# Work is in progress to further reduce maximum transverse size of QD0 cryostat.

# Space constraints continued....

Warm-to-Cold Transition

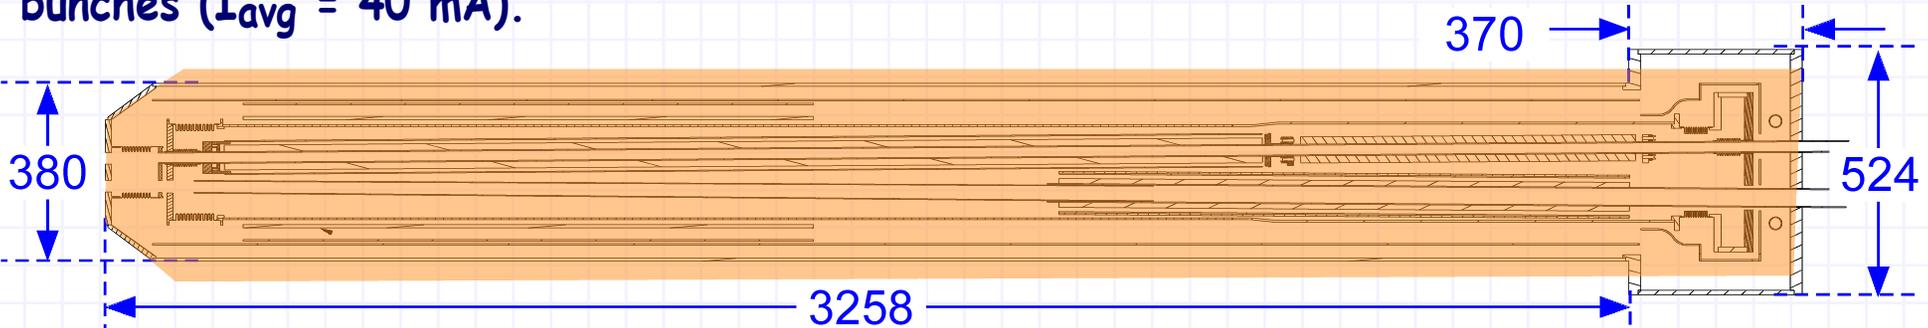
Do we need to shield these bellows? Remember that even a few watts of extra heat load (say due to wake fields) is quite significant at 2 K. Trade off between extra heat load via material in RF shield vs. a risk of heating due to broadband (and narrow band resonances) and sudden transitions with short bunches ( $I_{avg} = 40$  mA).

Assuming frequent push-pull exchanges and with QD0/QF1 being the only cold surfaces around, will there be a significant buildup of on the cold beam tube?

**Work is in progress to integrate anti-solenoid & reduce step.**

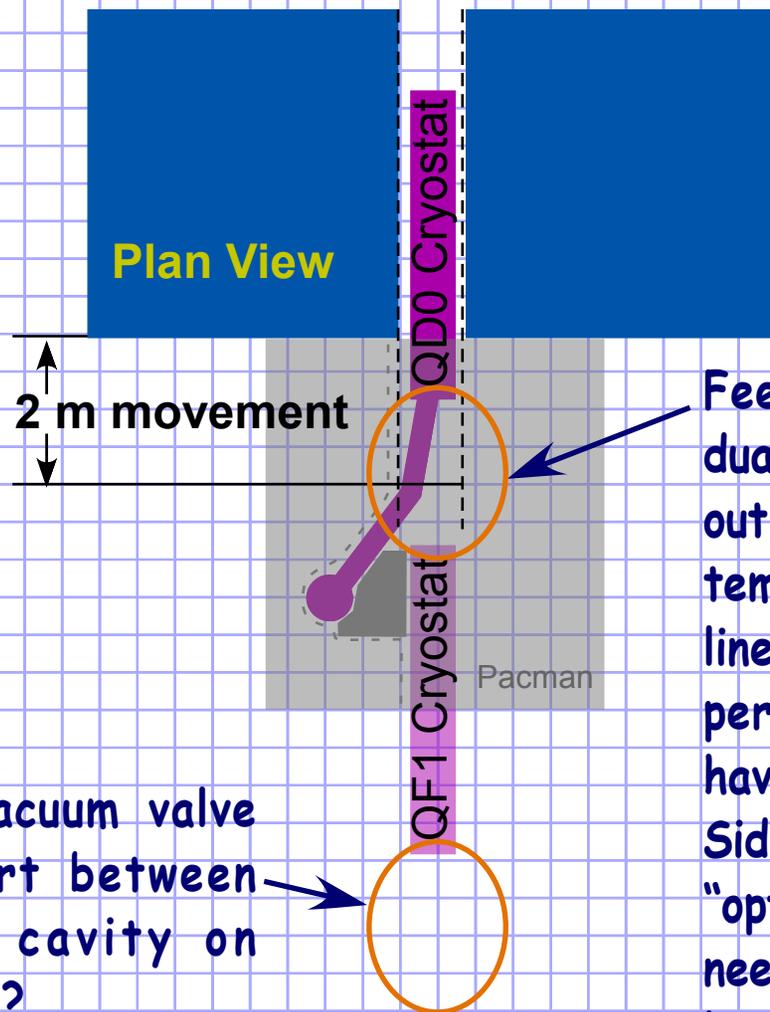
# Prohibit any line of sight penetrations through pacman to beam line.

Feedback kicker, BPMs, two sets of dual beamline vacuum valves and pump out ports must fit in this space. Is a temporary roughing pump out vacuum line connection enough or do we need permanently attached lines that also have to penetrate the pacman shielding. Side comment: what about discussion of "optical anchor" where there may be a need for some optical penetrations for laser beams?

Probably want vacuum valve and pumpout port between QF1 and crab cavity on incoming beam line?

**QD0-Service Cryostat connection line has to permit 2 m opening by door but vertical section must not point directly to incoming/outgoing beamlines.**

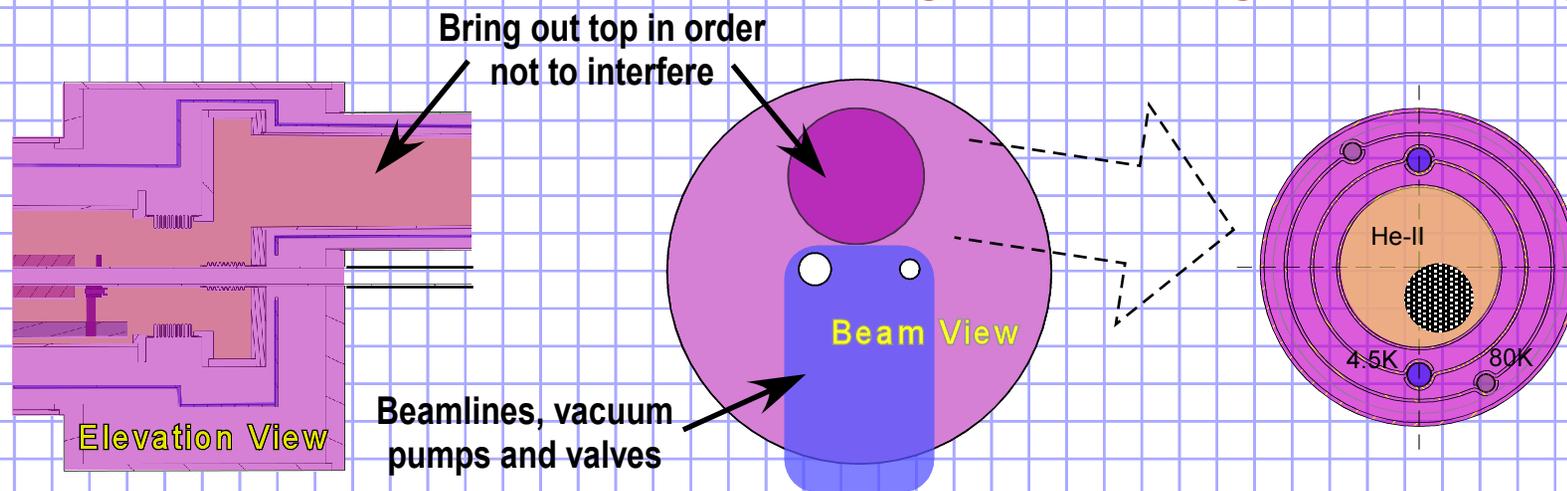
What is our budget for the space taken up by vacuum pumpout lines and the beam isolation valves? Must define relationship between cryogenic connection to QDO cryostat and other such equipment in this area.

**Work is in progress reducing the size of cryogenic lines.**

**Placement of vacuum pump lines and isolation valves also have to permit 2 m opening by door.**
